Access Compliance Report Public Rights-of-Way (Curb Ramps)

Intersection ID: 10029989Main Street:LANCASTER_HYCross Street:N/ALocation:NEADA ID: 38E5328D6751Ramp Type:ParaDiagInitial Pass/Fail:FailOverall Compliance:NoSeverity Score:13.75

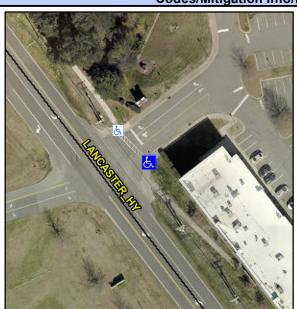
ENTRANCE StopSign LANCASTER HY None Remove & Replace Curb Ramp With Two New Directional Ramps or Equivalent.

R304.3.2, R304.5.3

Compliance Description Data		Compliance Description		Data	
N/A	Ramp Length LT (in)	67.0	N/A	Ramp Length RT (in)	62.0
Yes	Ramp Width LT (in)	60.0	Yes	Ramp Width RT (in)	59.5
No	Ramp Slope LT (%)	8.7	Yes	Ramp Slope RT (%)	7.0
Yes	Ramp XSlope LT (%)	1.6	No	Ramp XSlope RT (%)	3.5
N/A	Landing Length (in)	N/A	N/A	DWS Provided?	N/A
N/A	Landing Width (in)	N/A	N/A	DWS Contrast?	N/A
N/A	Landing Slope (%)	N/A	N/A	DWS Length (in)	N/A
N/A	Landing X Slope (%)	N/A	N/A	DWS Full Width?	N/A
N/A	Landing Curb? (Y/N)	N/A	N/A	DWS Offset (in)	N/A
N/A	Shared Landing?	N/A			
N/A	Gutter Ponding?	N/A	N/A	Gutter Slope (%)	N/A
N/A	Gutter Lip Ht (in)	N/A	N/A	Gutter X Slope (%)	N/A
N/A	Painted X Walk1?	Yes	N/A	Painted X Walk2?	No
	X Walk 1 Direction	To NW		X Walk 2 Direction	To SW
N/A	X Walk 1 Width (in)	52.0	N/A	X Walk 2 Width (in)	N/A
	X Walk 1 Slope (%)	3.9		X Walk 2 Slope (%)	6.0
	X Walk 1 X Slope (%)	4.9		X Walk 2 X Slope (%)	6.7
N/A	Ramp inside XWalk1?	Yes	N/A	Ramp inside XWalk2?	N/A
